PCN – Process Change Notification

Change:	OMB.450.B03F21
Date:	2016/07/12
Author	Kim Ho

Model#	Part Number	Changes
450MHz 3dBi Omni Antenna with N Type Female Connector , U-Bolt 523mm Length Ø70*55mm	OMB.450.B03F21	Amend Aluminium tube brackets.

Old drawing

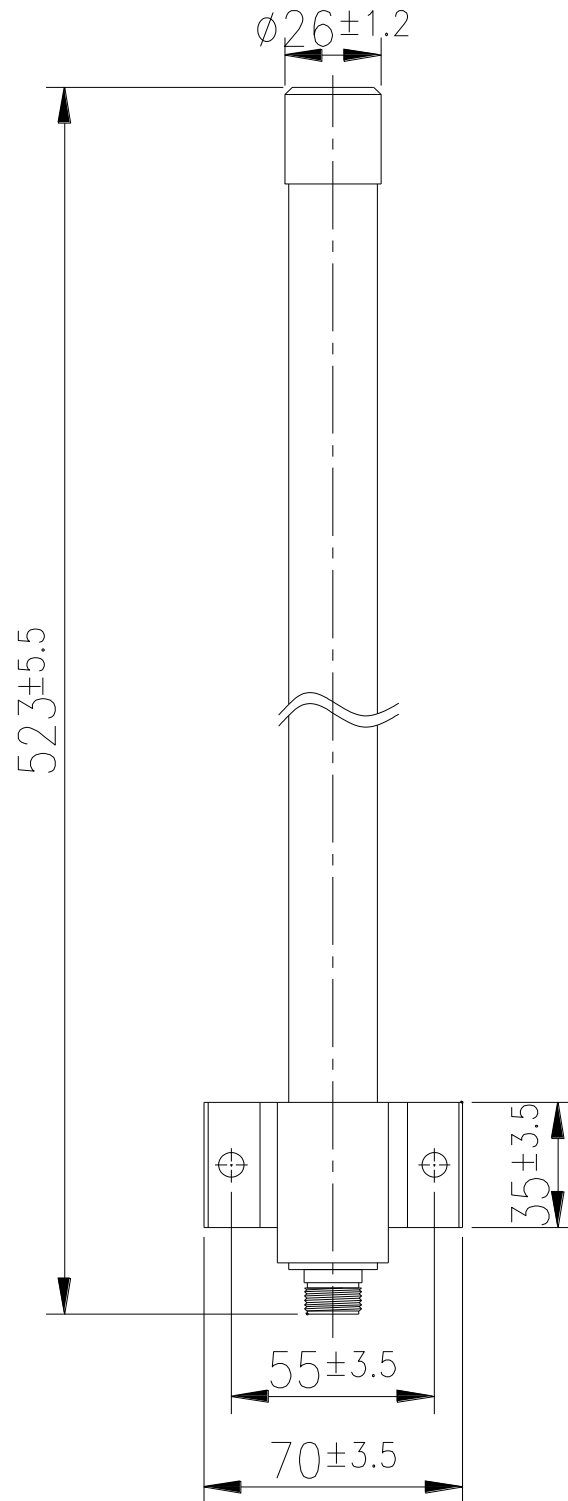
- Due to antenna performance, Aluminium tube brackets size need to amend from 35mm to 53mm. also change two mounting holes to four mounting holes.
